Submission: Bourke St, Mascot – Cycleway Proposal

Background & context

Separated bidirectional cycleway on road
(12.8m minimum kerb to kerb)

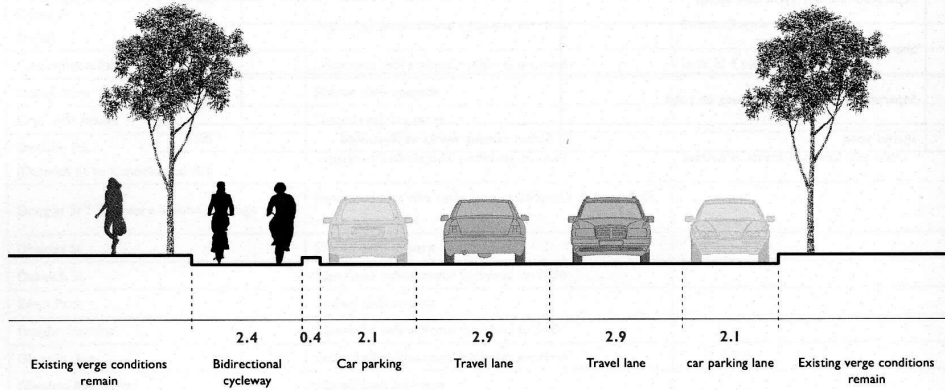
Two-way separated bi-directional cycleway is the preferred option

Shared path on verge

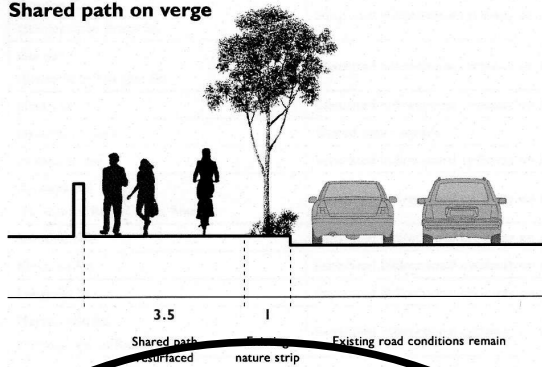
Bi-directional cycleway – on-road and shared path combination alternative to two separated one-way cycleways proposed for Bourke Street, Mascot.
